Access Compliance Report

Public Rights-of-Way

Intersection ID: 7280	Main Street: N_I-85_EXIT_41_RA	Cross Street: W_SUGAR_CREEK_RD	Location: SW
ADA ID: 0F4E3C547867	Ramp Type: Para	Initial Pass/Fail: Fail	Overall Compliance: No
Codes/Mitigation Info/Possible Solution		Field Measurements/Component Compliance	
Severity Score: 12.5

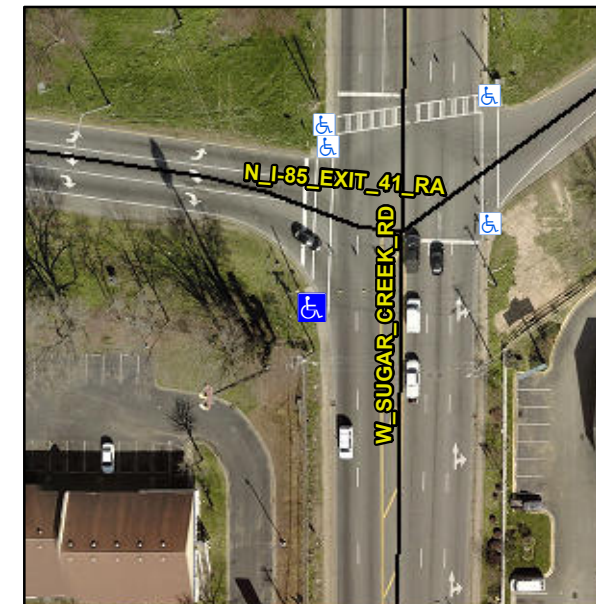
LT RP < 5%

R304.3.2

Remove & Replace Entire Ramp.
